**N0322/14 – 2 and 4 Jenkins Street and 1679 Pittwater Road, Mona Vale  
(Lots 1, 2, 3, and 4 DP 23373 and Lot 15 Section A DP 5464)**

**Demolition of all existing site improvements and construction of a new residential care facility, comprising 77 bedrooms and 89 beds, under the provisions of SEPP (Housing for Seniors and People with a Disability) 2004**

**SUMMARY OF RECOMMENDATION:** Refusal

Figure 2 - Plan provided by applicant demonstrating area of height non-compliance.

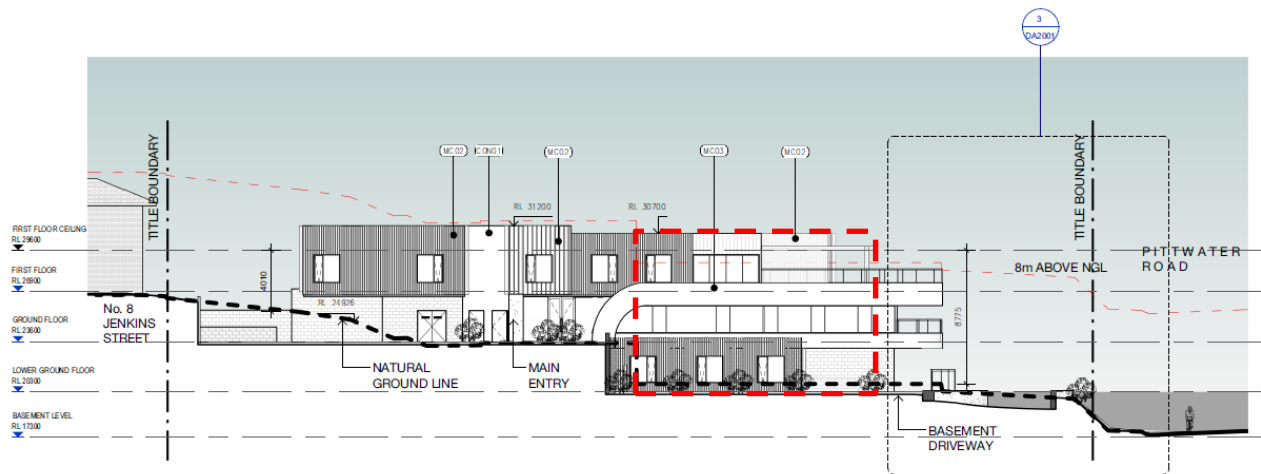
Based upon the elevations and an RL of 29.6 for the upper floor ceiling, the proposal is inconsistent with the 8m maximum height development standard prescribed by clause 40(4)(a) of SEPP HSPD. This height non-compliance occurs along the entire eastern frontage of the proposed building, extending back into the building with a maximum depth of 20m, and resulting in an area of approximately 379m<sup>2</sup> of the upper floor breaching the height plane. The extent of height non-compliance is demonstrated by Figure 2, below.

The proposal is non-compliant with the 8m maximum height limit prescribed by clause 40(4)(a) of SEPP HSPD. The maximum building height limit is a development standard, as defined by the *Environmental Planning and Assessment Act 1979*, and as such, the provisions of clause 4.6 (Exceptions to development standards) of PLEP 2014 can be applied.

Figure 3 - Southern Elevation with two storey height non-compliance outlined in red

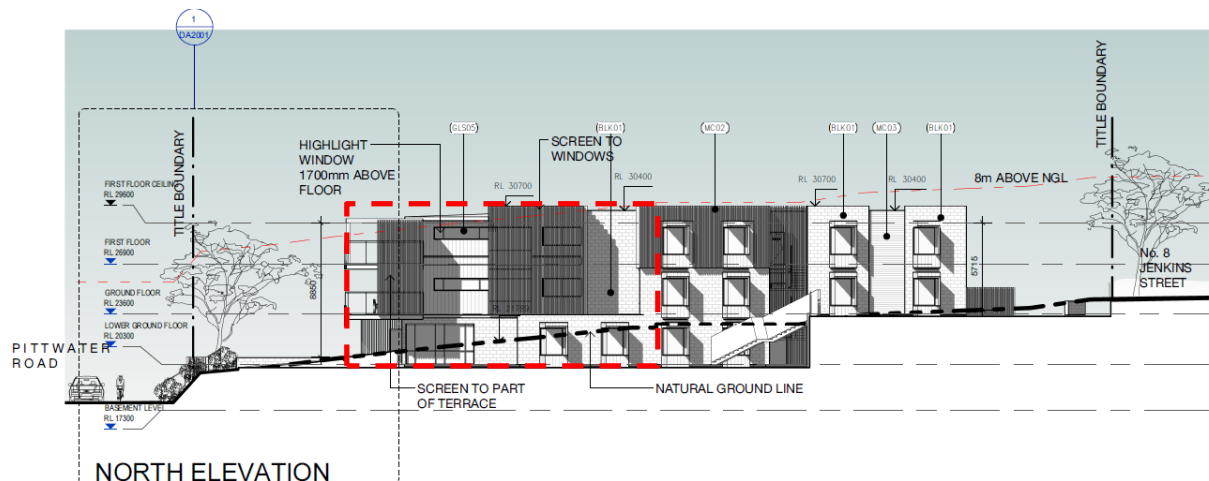
There are three main points at which the building presents with more than two storeys to a boundary; the 17m overlap of the first floor, ground floor and lower ground floor on the Jenkins Street front facade, the 16m overlap of the first floor, ground floor and lower ground floor on the Pittwater Road front facade, and the 20.5m overlap of the first floor, ground floor and lower ground floor along the northern side facade. These areas are highlighted in red on the elevations, below.

The proposal is non-compliant with the two storey height limit prescribed by clause 40(4)(b) of SEPP HSPD. The two storey height limit is a development standard, as defined by the *Environmental Planning and Assessment Act 1979*, and as such, the provisions of clause 4.6 (Exceptions to development standards) of PLEP 2014 can be applied.

Figure 7 - Height pole location and height certification, provided by applicant.

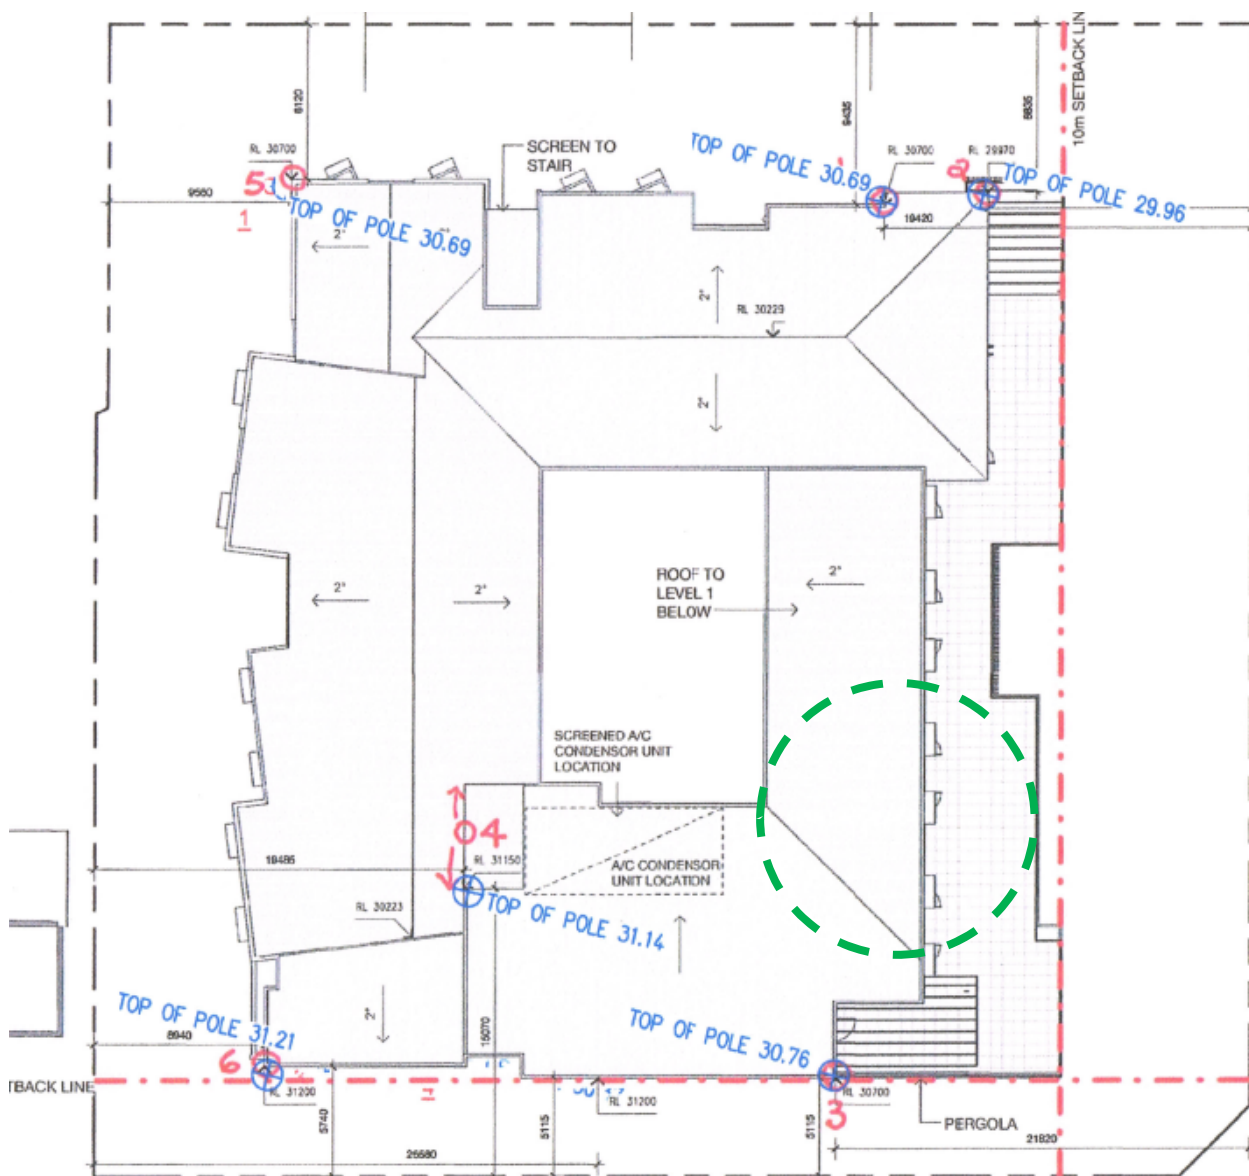
Following the previous deferral of the matter, the applicant has since erected 6 height poles on the site, to demonstrate the potential impact of the proposed development upon views currently obtained across the site. The location and height of the poles erected on site are shown in Figure 7, below. It is noted that there is no pole to demonstrate the impact of the portion of the development that has the greatest variation to the building height control, as identified by the dashed green circle.
